Access Compliance Report

Public Rights-of-Way

(Curb Ramps)

Intersection ID: 52716	Main Street: AGAVA_LN	Cross Street: MAIDENHAIR_CT	Location: NE
ADA ID: E964F2A78503	Ramp Type: Perp	Initial Pass/Fail: Fail	Overall Compliance: No
Codes/Mitigation Info/Possible Solution		Field Measurements/Component Compliance	
Severity Score: 13.75

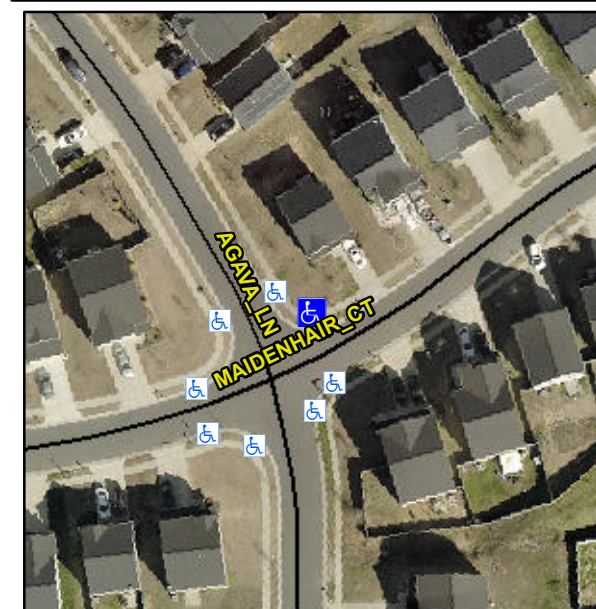
Not Found, R304.2.2, R304.5.3

Compliance	Description	Data	Compliance	Description	Data
N/A	Ramp Length (in)	46.0	No	Ramp Slope (%)	8.4
Yes	Ramp Width (in)	48.0	No	Ramp XSlope (%)	4.2
N/A	Flare Type LT	N/A	N/A	Flare Type RT	N/A
N/A	Flare Slope LT (%)	N/A	N/A	Flare Slope RT (%)	N/A
N/A	Flare Traversable LT?	N/A	N/A	Flare Traversable RT?	N/A
N/A	Landing Length (in)	N/A	N/A	DWS Provided?	N/A
N/A	Landing Width (in)	N/A	N/A	DWS Contrast?	N/A
N/A	Landing Slope (%)	N/A	N/A	DWS Length (in)	N/A
N/A	Landing X Slope (%)	N/A	N/A	DWS Full Width?	N/A
N/A	Landing Curb? (Y/N)	N/A	N/A	DWS Offset (in)	N/A
N/A	Shared Landing?	N/A			
N/A	Gutter Ponding?	N/A	N/A	Gutter Slope (%)	N/A
N/A	Gutter Lip Ht (in)	N/A	N/A	Gutter X Slope (%)	N/A
N/A	Painted X Walk1?	No	N/A	Painted X Walk2?	N/A
	X Walk 1 Direction	To S		X Walk 2 Direction	N/A
N/A	X Walk 1 Width (in)	N/A	N/A	X Walk 2 Width (in)	N/A
	X Walk 1 Slope (%)	3.1		X Walk 2 Slope (%)	N/A
	X Walk 1 X Slope (%)	2.9		X Walk 2 X Slope (%)	N/A

Remove & Replace Entire Ramp.
